Preliminary Plan 120061120, Glen Echo Heights

Staff Report Date: 2/12/16

- Resubdivision of two lots into three lots for one one-family detached dwelling unit on each lot
- Located on the east side of Walhonding Road, 800 feet west of the intersection with Wiscasset Road
- 0.84 acres
- R-90 zone
- *Bethesda – Chevy Chase Master Plan*
- Application received on May 4, 2006
- Applicant: Alidad Hakimi
- Chapter 50, Chapter 22A

RECOMMENDATION: Denial

Figure 3 Preliminary Plan

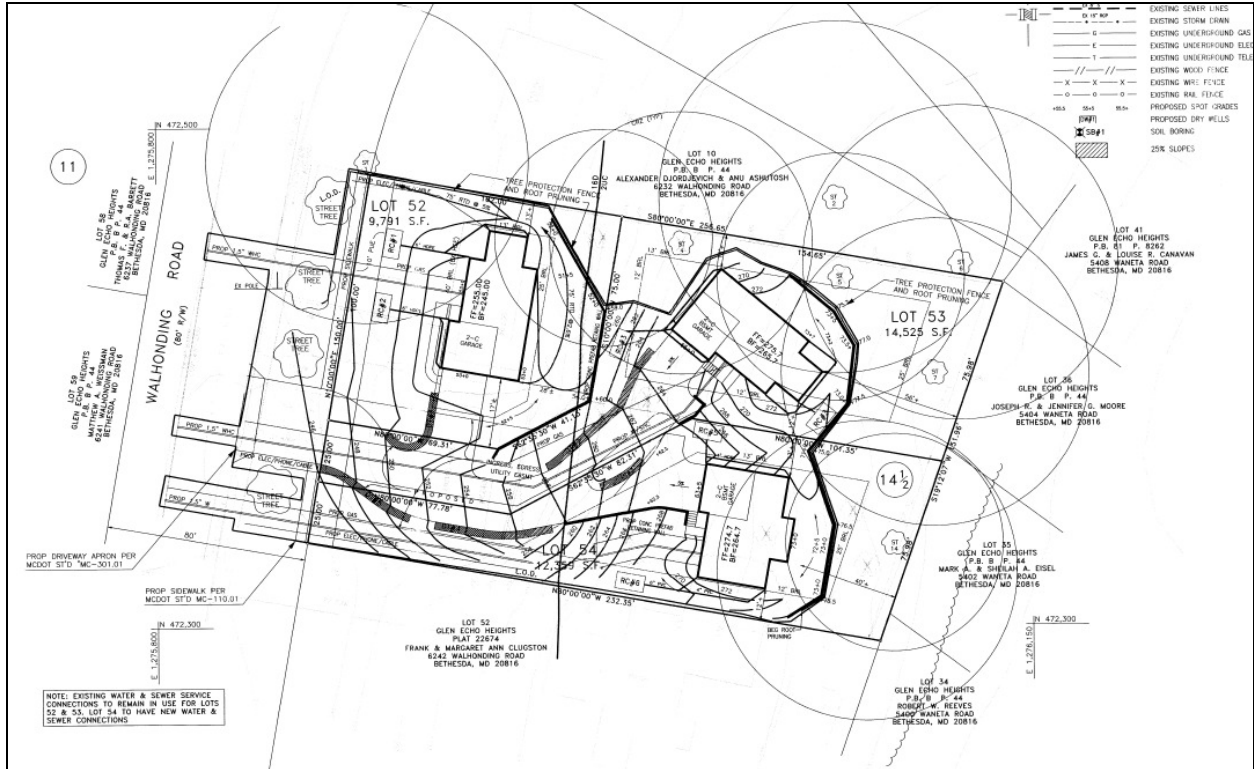
Contrary to this recommendation, the application proposes to disturb the sensitive topography and associated vegetation, which may lead to erosion. The preliminary plan shows that grading will take place in areas in excess of 25% slope and that contain erodible soils.

Figure 5 Boring location map

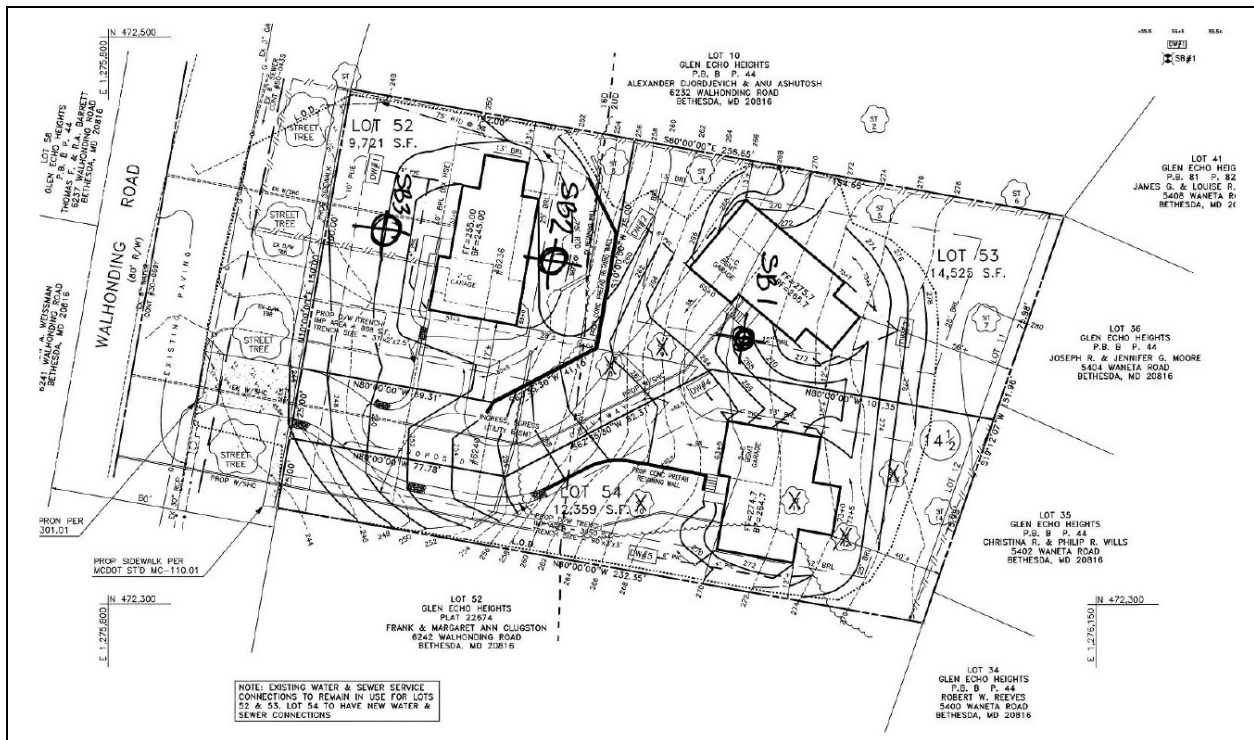
However, the geotechnical report does not appear to support this conclusion. The boring log for boring location SB-1 indicates that silt loam (the erodible soil) was encountered between boring depths 3 to 4.5 feet below the ground surface (at an elevation between 266 and 267.5 feet above sea level). Contrary to the statements in the geotechnical report and Mr. Orens's letter that this boring was performed in an area that would remain relatively undisturbed between the existing houses and the street, the boring location map shows that boring SB-1 was performed on the steep slopes towards the rear of the property, in an area where extensive grading would take place to develop the subject property. As shown on the preliminary plan, the proposed house on proposed Lot 53 would have a basement with a floor elevation of 265.7 feet, which means that the silt loam found between elevation 266 feet and 267.5 feet would be disturbed during construction of the house.

Figure 6 Forest Conservation Plan showing trees to be removed

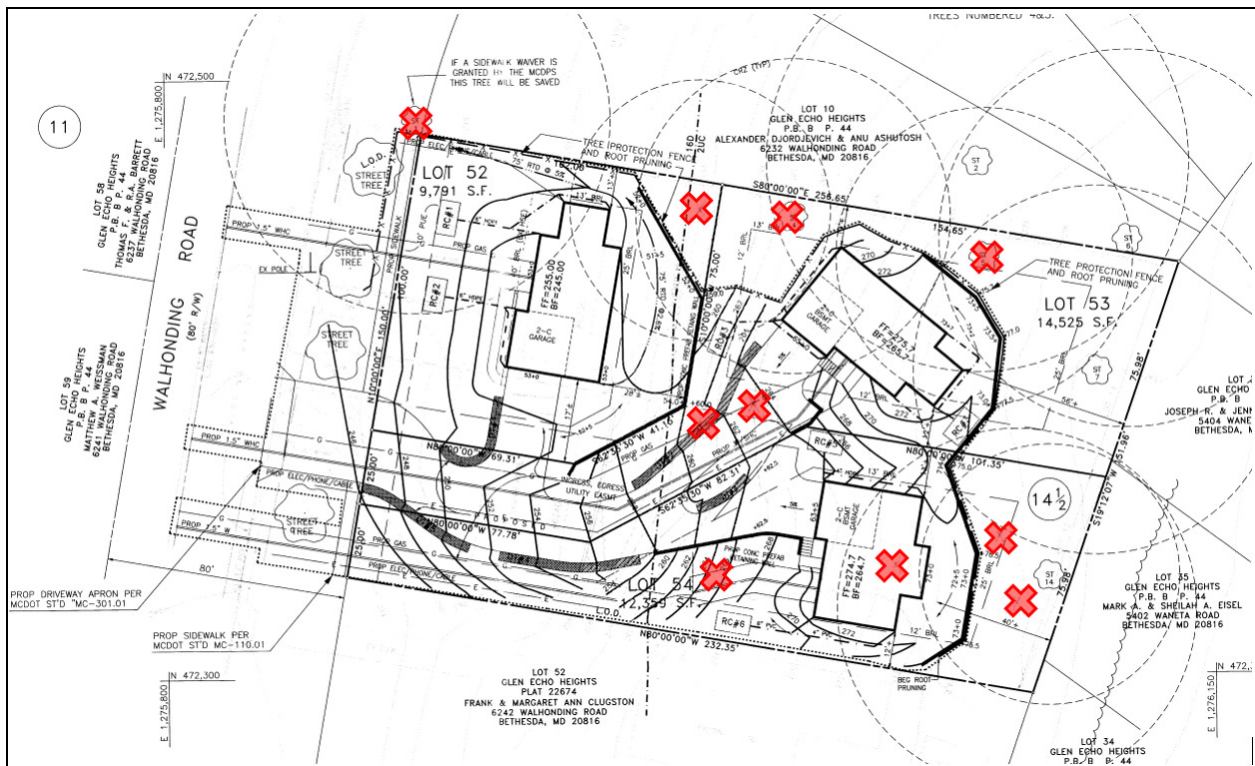
impacts and removals of subject trees (see Attachment D, variance request). However, the applicants' variance application contained several errors, including conflicting information between the tabular data and the plan drawing on the number of subject removals and impacts. There are 7 or 8 (based on the tabular data and the plan drawing, respectively) trees proposed for removal and another 7 or 8 trees that are proposed for impact that are considered high priority for retention under Section 22A-12(b) (3) of the Forest Conservation Law.

The proposed development excessively encroaches into environmentally sensitive areas comprised of mature trees and forested steep slopes associated with highly erodible soils, in conflict with the forest conservation law and variance provisions, the *Environmental Guidelines*, Master Plan recommendations, and the Subdivision Regulations. Staff has reviewed this application and does not agree that there is an unwarranted hardship that would deny the applicant reasonable and significant use of the property if a variance is not granted.
